U-Penn ASIC Carrier Board

Inspection Images

Date: 12/12/2018

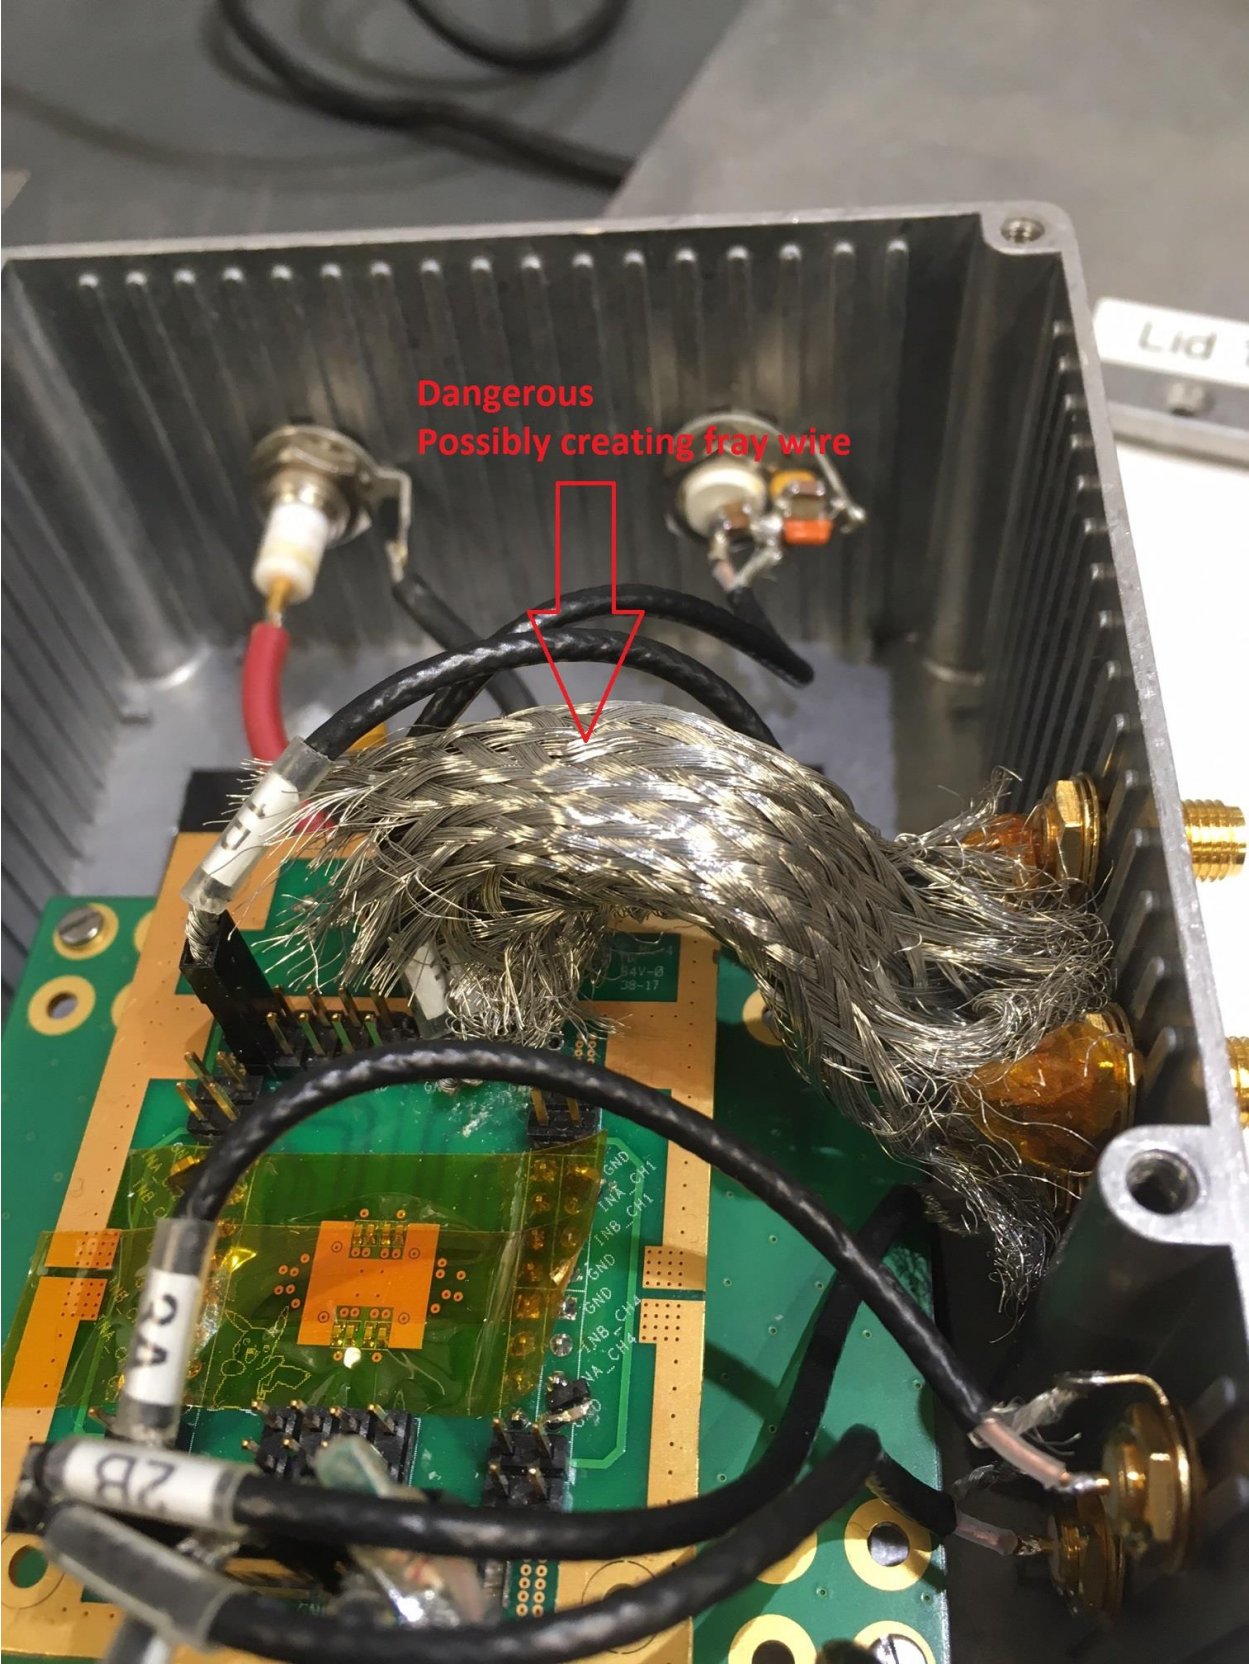
U-Penn (Mitch's Comments): APD on the carrier board with
>> the trenching around the ground plane. When it arrived we found
>> that the PCB needed to be cleaned with surface mount components
>> removed to eliminate leakage currents. This worked and were able to
>> bias up to 1750V with leakage current well below 1uA. With the
>> amplifier connected we saw substantial oscillations which were
>> quieted down to less than a mV on the output by covering the output
>> cables with braid. To get a good gain calibration we then tried to
>> measure the Fe55 peak. Biasing the APD again we got a measurement with
>> a lower than expected gain.
>> After making a small change again on the FASTAMP board the APD
>> current became a significant problem again. After ensuring that
>> the HV hookup was not leaking we decided to send it back to you to
>> see if you could identify the source of leakage. We saw no evidence
>> of leakage when the series biasing resistor on the carrier board

>> just before the APD was removed placing the location of the leakage
>> current around or in the APD.

Princeton (Bert's Comments): > Before I got started I confirmed the 20M ohm reading you saw at Penn.

> Actually this 20Mohm is the sum of the (4) 5Mohm series R's. Probing
> the APD I measure a DC resistance of about 480K (very low). So the
> actual measurement from the HV connector was the 20M + 480K or 20.48M
> ohm. I managed to take several photos of suspicious concern before
> removing the wirebonds and mesh (I will share them shortly). After removing the mesh I
> isolated the APD and DC probed it and still measured the 480K. I then
> took the PCB up into my cleanroom and did an ultrasonic solvent clean
> with Acetone followed by an Isopropanol rinse. My last stop was in
> our barrel asher for a soft non-biased o2 plasma clean for 5 minutes.
> I returned to my lab and probed what now seems to be expected on
> the measurement of the APD (many meg ohm 20+). I will have to replace
> the screen and wirebond it before it can be retested. We may want to
> have Mickel coat it as the images I will share show quite a bit of

> hygiene concerns.

Dangerous
Possibly creating fray wire
